Bridge Preliminary Design Report

**SR-823 over Fairground Road
Bridge No. SCI-823-1594**

**SCI-823-10.13
PID No. 79977**

- ODOT Review Comments to Structure Type Study with Consultant Responses

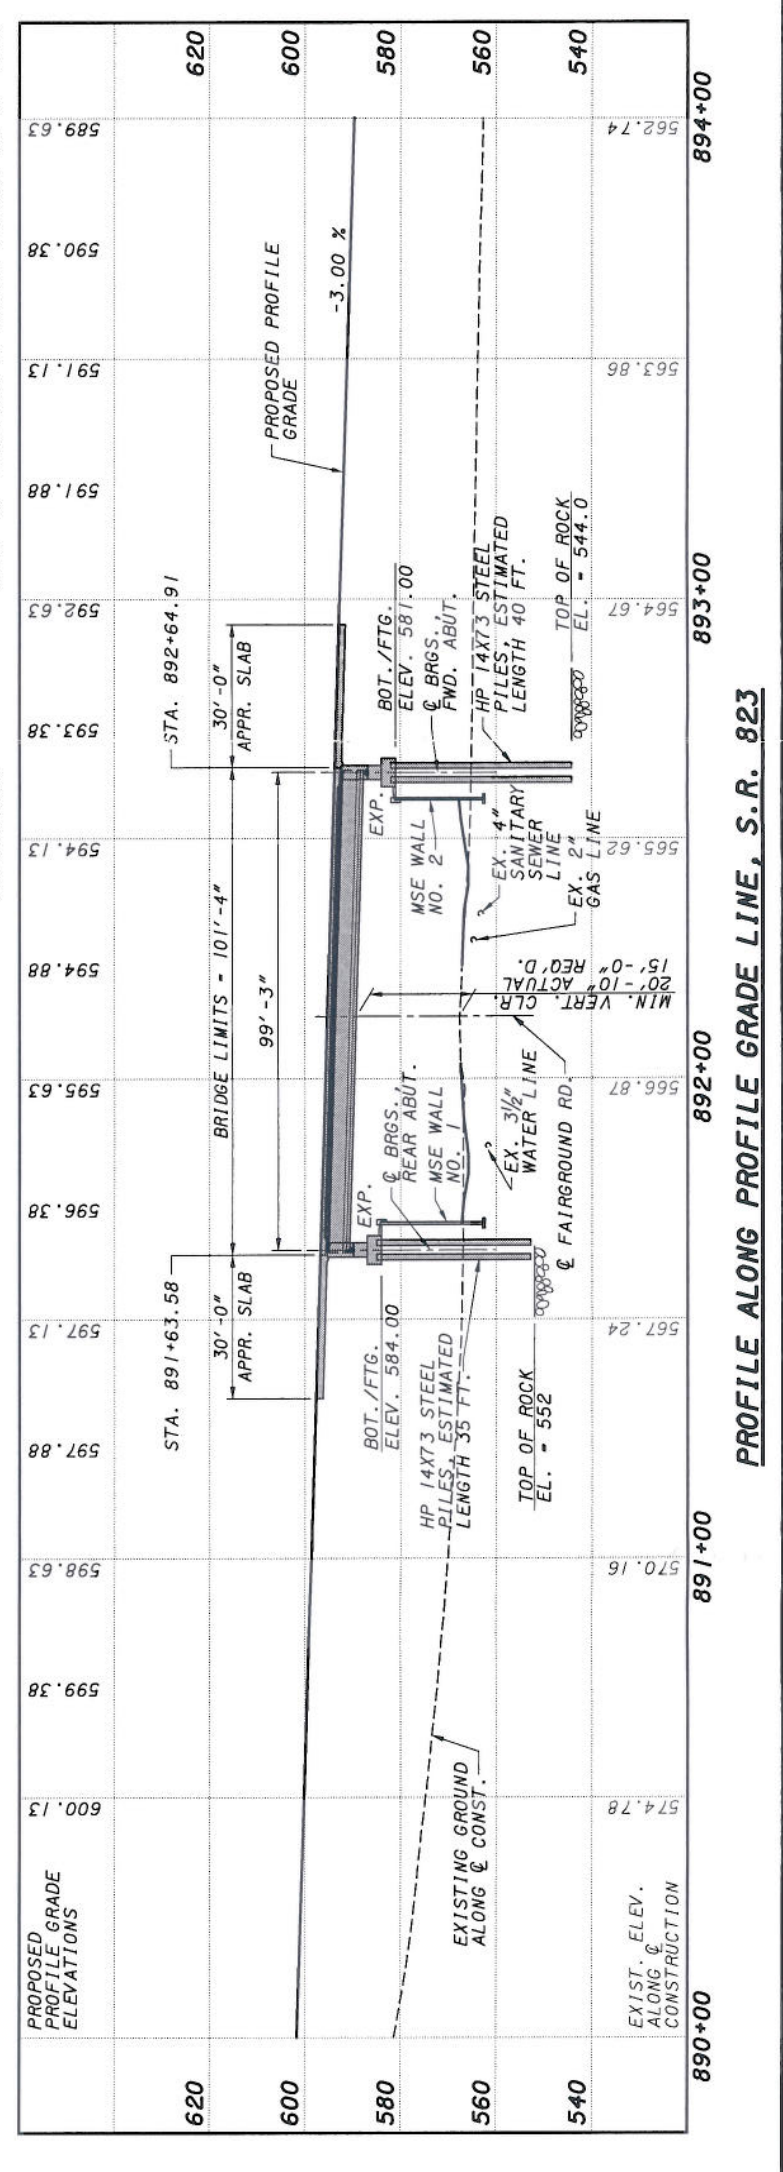
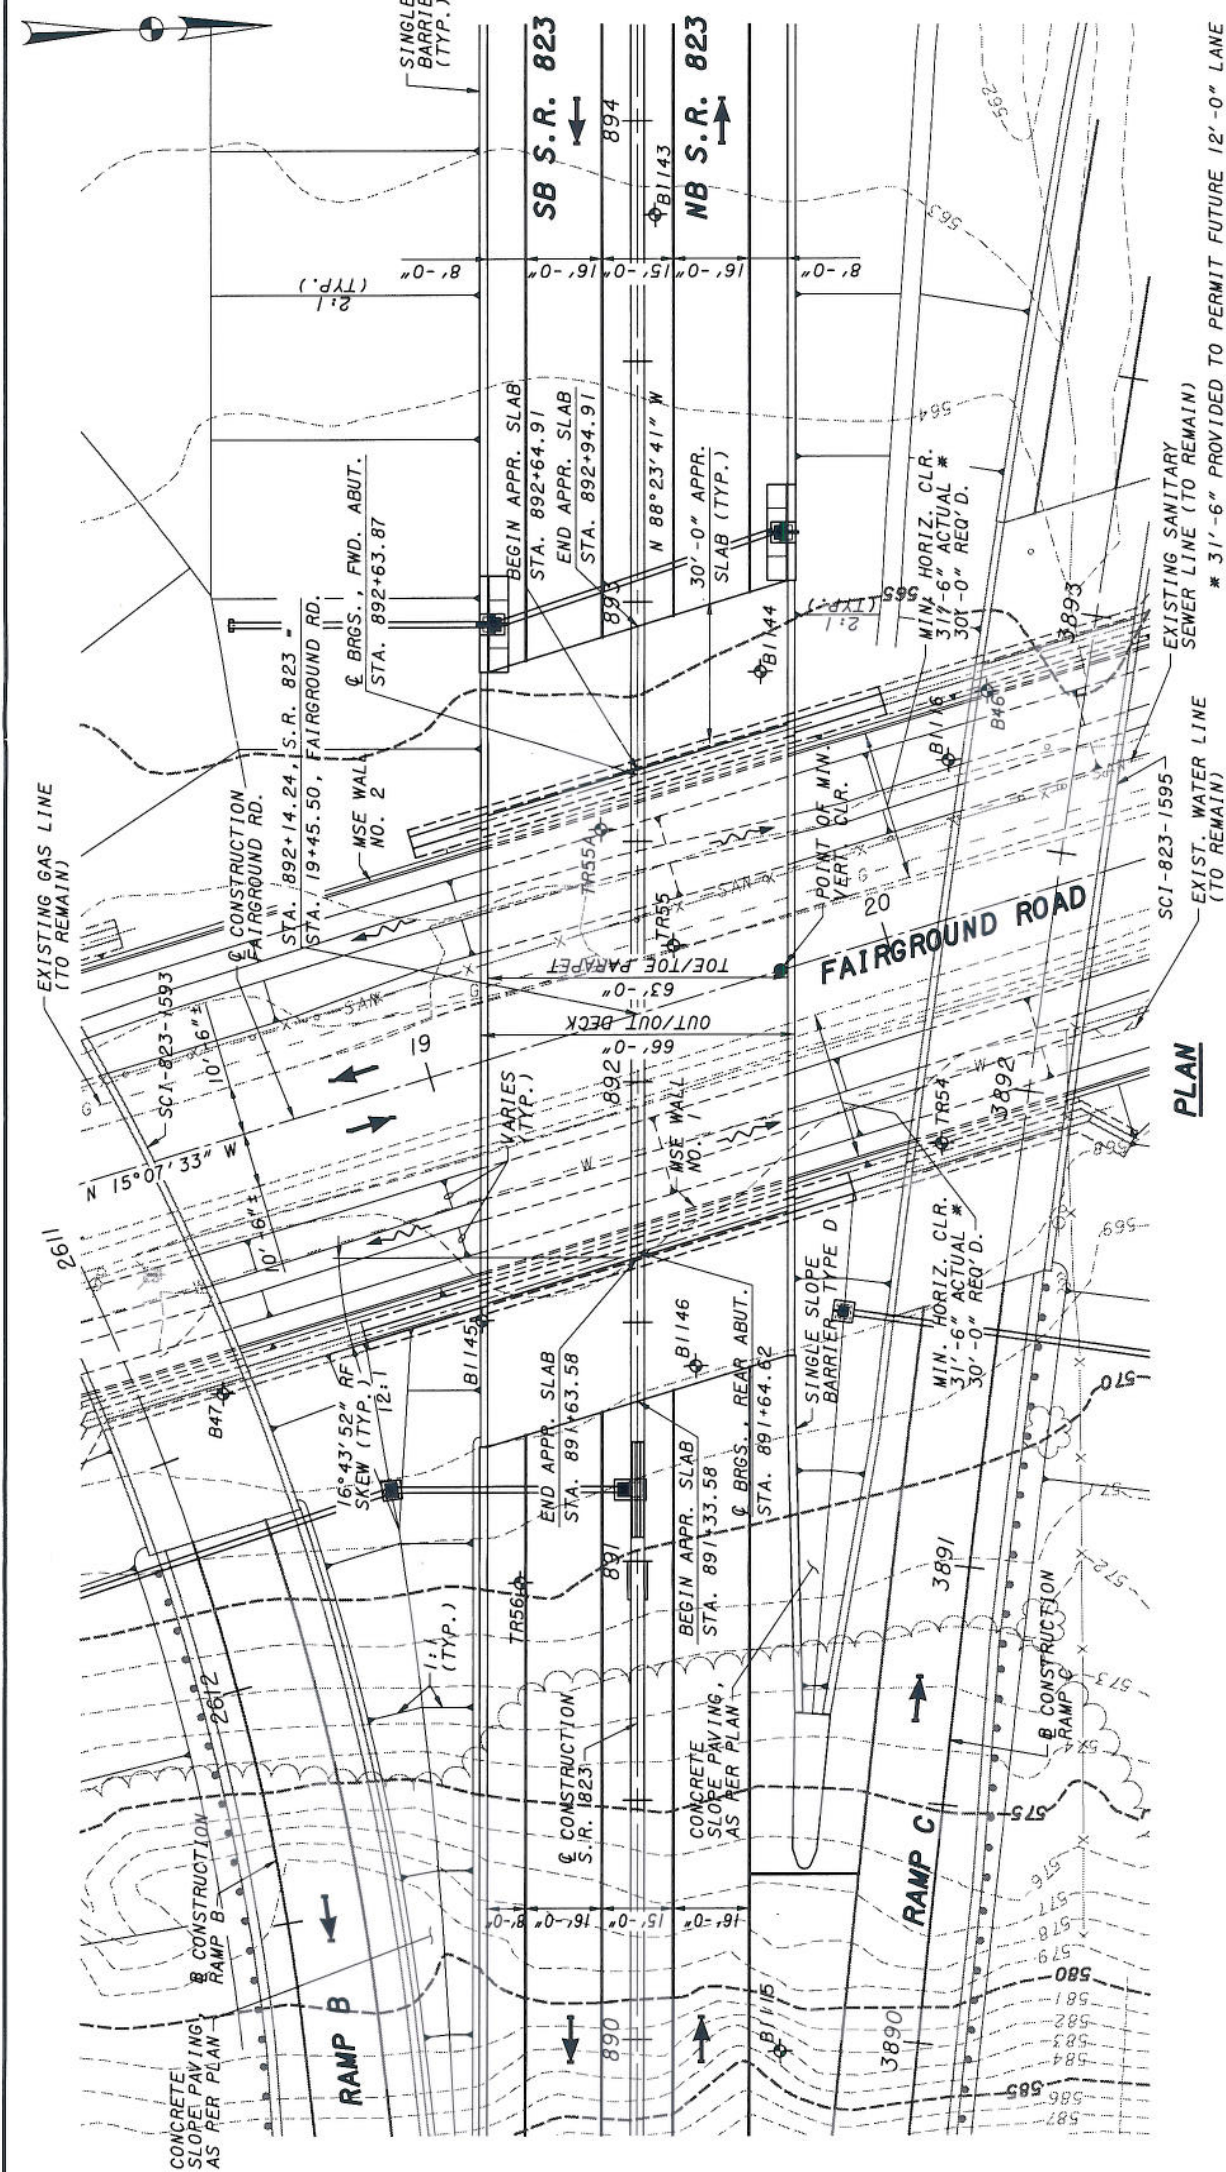
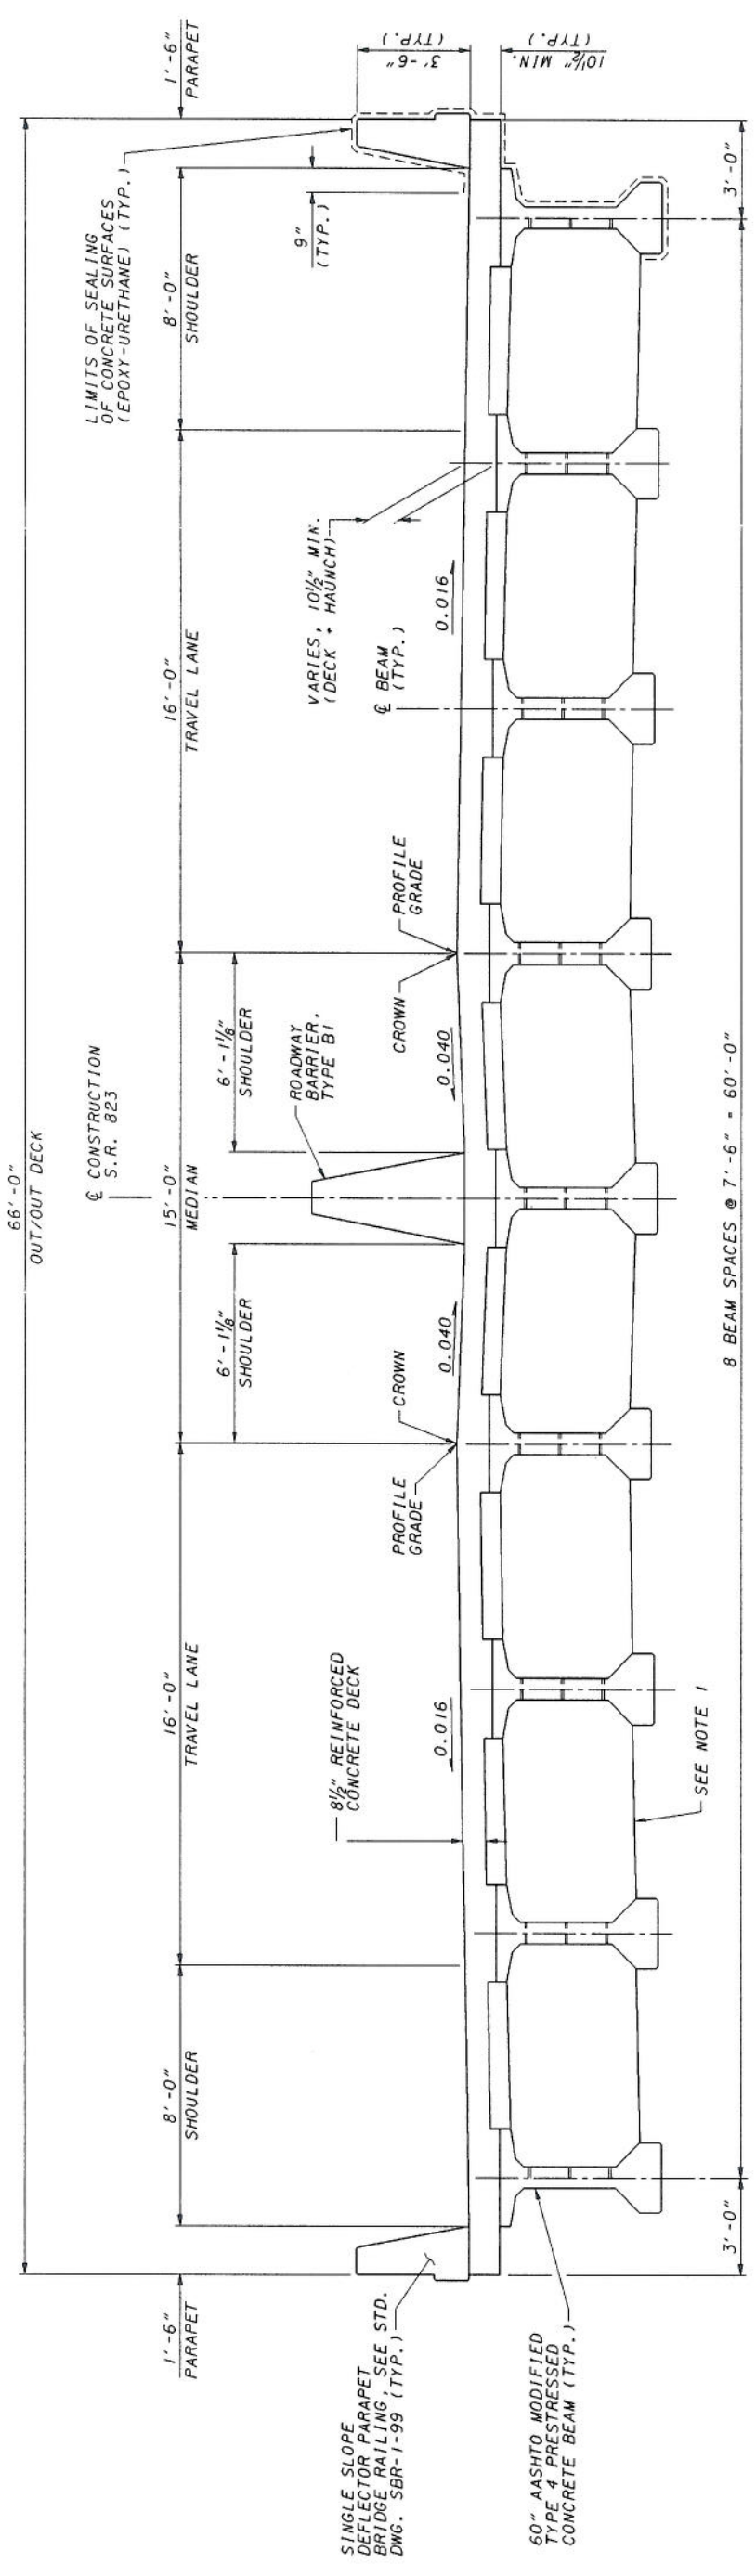
<p>Site Plan (1/3)</p>	<p>4. We could not verify the 30'-0" proposed horizontal clearance after referring to ODOT's L&D Manual, Volume 1, Fig. 600-1. What is the ADT for Fairground Road? Please make sure that approval of horizontal clearance is obtained from ODOT - Office of Roadway Engineering Services prior to proceeding.</p>	<p>See attached documentation pertaining to design/posted speed and design year ADT along Fairground Road to justify the required 30'-0" clear zone distance to the MSE walls. Since the PAVR submittal, CH2M HILL has had discussions with the Scioto County Engineer's Office. The county stated that Fairground Road will be improved to 2-12' lanes and that the speed limit is 55 mph. With a design speed of 60 mph and an ADT greater than 3000 vpd, Fig 600-1E recommends a clear zone distance of 30'-0" when the ditch foreslope varies between 6:1 to 4:1. Due to additional culverts being added along Fairground Road, new ditches are being designed with foreslopes varying from 6:1 to 4:1; the steeper than 6:1 foreslope also provides the avoidance of utilities, while also using existing drainage structures. Providing lateral bridge clearance equal to the clear zone provides a safer roadway and allows for future improvements.</p>

<p>Site Plan (1/3)</p>	<p>5. When the deck drainage is to flow off the bridge, provisions must be made to collect and carry away this run-off. Please refer to the Bridge Design Manual (BDM) section 209.3.</p>	<p>Will comply.</p>
<p>General</p>	<p>6. The Geotechnical report did not include recommended side resistance for the drilled shafts. This should be provided, as some of the drilled shafts at the piers may be subjected to uplift loads.</p>	<p>Uplift forces may have been anticipated in some of the preliminary multi-span options. However, the currently proposed structure is single span and uplift forces are not a concern. However, if the design should change, we will provide design parameters for drilled shafts subject to uplift.</p>

Site Plan (1/3)	7. We could not verify the boring log TR-55 shown on the site plan in the geotechnical report.	We recognize that the log for boring TR-55 was not included in the October 4, 2006 geotechnical report. It was inadvertently left out of the report. It will be added to the final report for the interchange.
General	8. Include the Structure File Number in the Title Block. The Structure File Number for this bridge is: 7306725. For future projects, Structure File Number can be obtained by contacting Ms. Kathy J. Keller, Office of Structural Engineering, Bridge Inventory section (Ph. 614-752-9973).	Will comply.

REAR AND FORWARD ABUTMENT SECTION

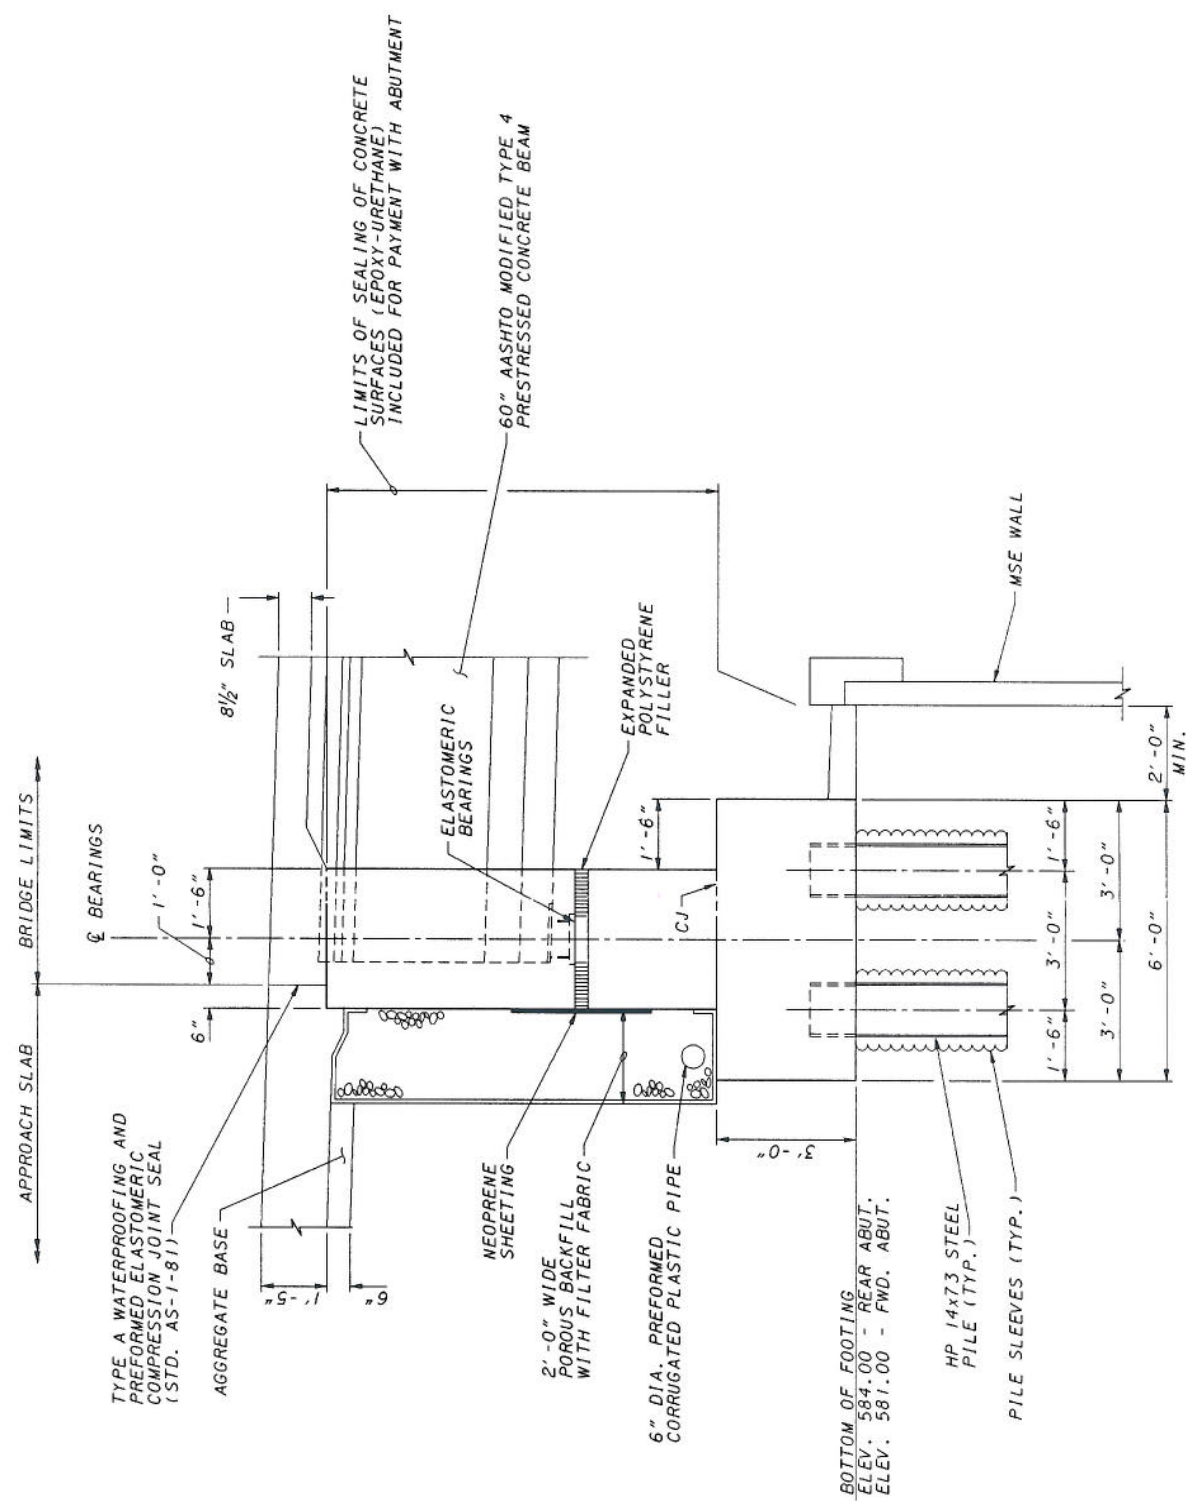
2. Rear Abutment Section - Ramp B (Sheet 3 of 3): See comment 1 above.
3. Forward Abutment Section - Ramp B (Sheet 3 of 3): The approach embankment and end slope are approximately 30-ft in height. Since this height of fill is nearly the same as MSE Wall 2, this approach embankment and end slope will likely be constructed in stages. Assuming the construction sequence is to build the embankment in stages, drive piles through hollow cans, fill the cans with sand, construct the abutment, and then place the ten feet of fill to bottom of the approach slab, and no surcharge load is to be

- a. Bending Stresses in the Battered Piling: The plans show a front row of battered piles. The downward movement of the soil will induce bending in the piles. The magnitude of stress and impact on the performance of these piles will need to be considered.
 - b. This settlement will occur in the soils below the cans. Therefore, downdrag will need to be considered in the portion of the piles below the cans.
 - c. If straps are to be placed on the abutment backwall for lateral restraint of the backfill soils, the primary and long term secondary settlement could pull the straps downward and cause possible rotation of the backwall, structural distress, and/or break the strap connections.
 - d. Impact of primary and long term secondary settlement on the approach slab.
4. Ramp C: Please see comments 1-3 above.

Figure 1 - Soil Profile for MSE Wall 2

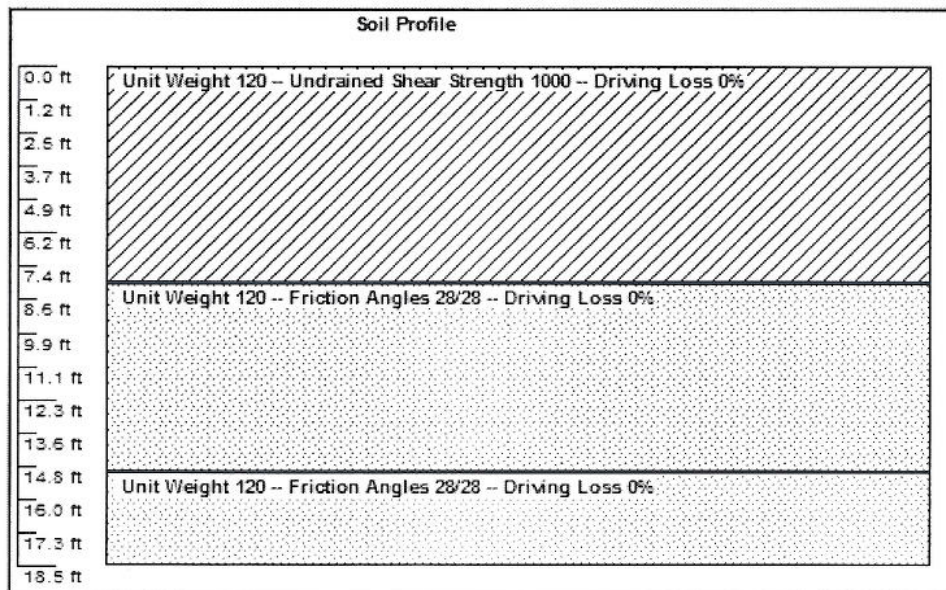
1. MSE Wall 2: The DLZ design computations in Appendix IV, page 1 of 21, show a geotechnical design profile as follows:
 - a. Ground surface of the boring (elevation 566-ft) to elevation 548-ft (18-ft below ground surface) is a silty clayey material with an undrained shear strength of $C = 1,500$ psf.
 - b. From elevation 548-ft down to elevation 544-ft (22-ft below ground surface) is a sandy material.
 - c. Top of Rock is encountered at elevation 544 (22-ft below the ground surface).
 - d. Water Table is encountered at elevation 550-ft = 16-ft below ground surface.

However, all the MSE Wall 2 borings show a predominately loose sand (79% sand and gravel) with an estimated friction angle of approximately 28-degree (based on N value corrected for overburden) at a depth of approximately 8-ft (elevation 558-ft). This layer extends down an additional 7-ft to elevation 551-ft. The "sand and gravel" layer encountered is a very loose to loose sandy gravel, also with an estimated friction angle of approximately 28-degrees. This layer extends to the top of rock (elevation 544-ft).

I would recommend re-evaluation of the borings for MSE Wall 2, and performing slope stability analysis using the profile depicted below in Figure 1. In particular, I recommend replacing the friction angle of the gravel sand at the rock interface with a more appropriate value of 28-degrees.
